PLANNING BOARD MEETING AGENDA

Thursday September 19, 2019

To: Berwick Planning Board
From: Lee Jay Feldman, Director of Planning
Date: 9/11/2019
Re: **Site Plan Review Hussey School Expansion**

PROPOSED SITE MODIFICATIONS
THE VIVIAN E. HUSSEY SCHOOL, TAX MAP R-57, LOT 27
BLACKBERRY HILL ROAD, BERWICK,
YORK COUNTY, MAINE

L6
 SHEET: 6 OF 7

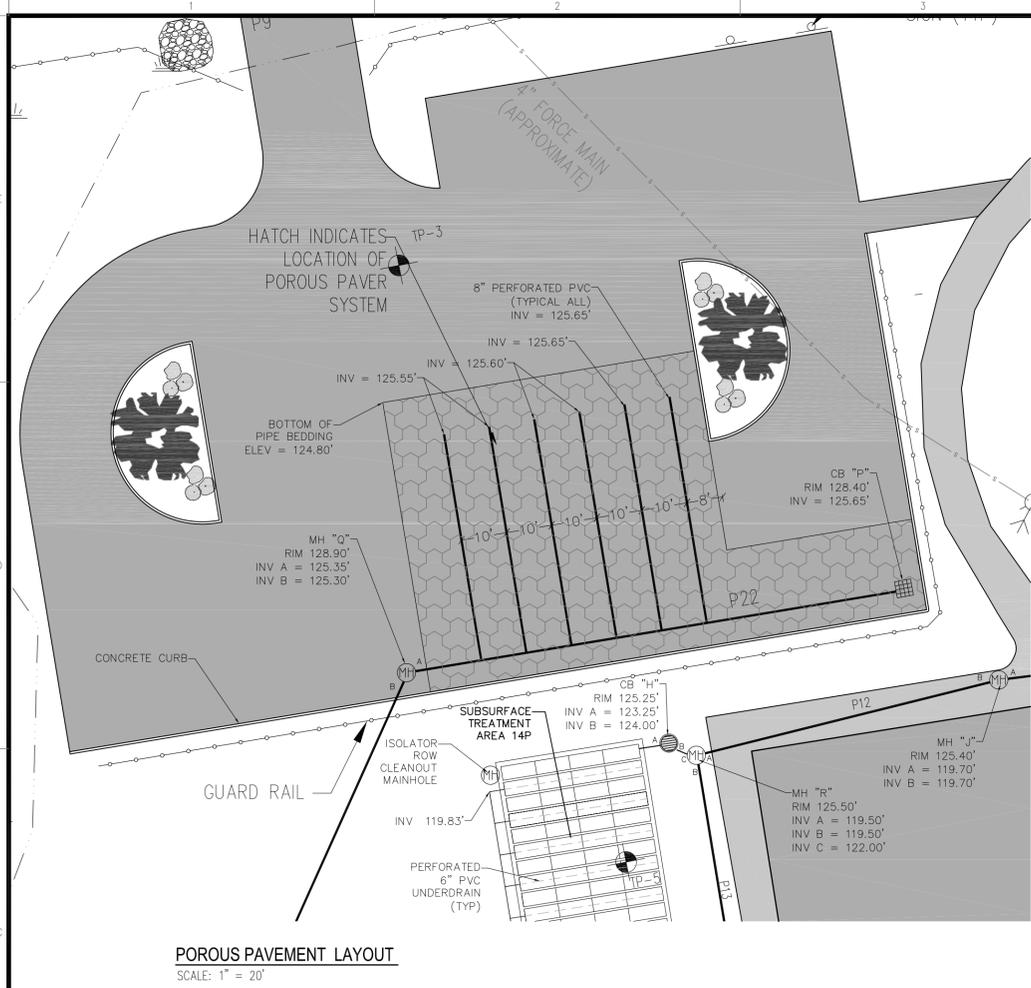
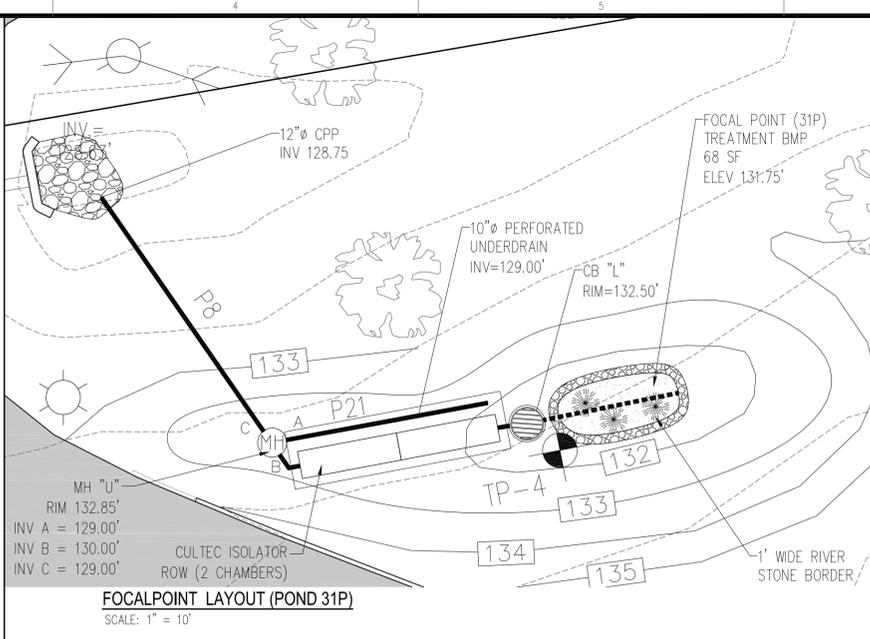
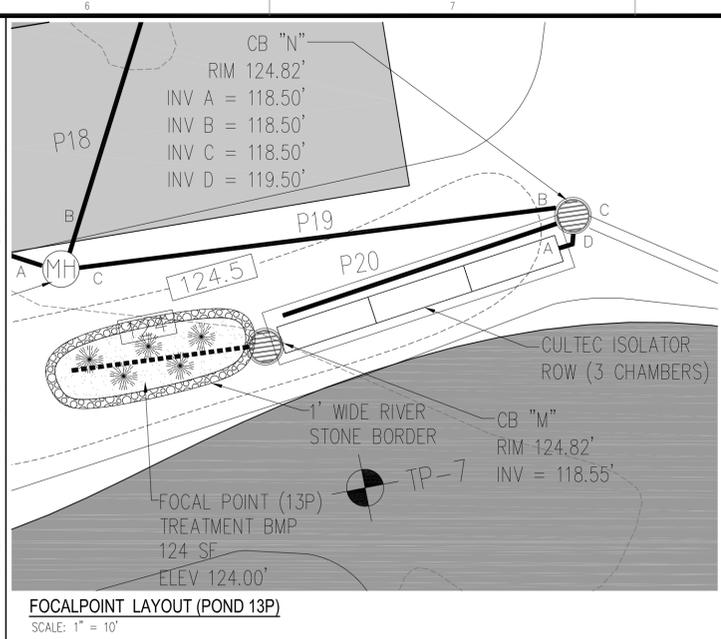
The stormwater system proposed is somewhat complicated to explain so for the intricate details I would suggest reviewing sheets L4 & L5 of the plan set for plans that have been blown up to see what is going on.
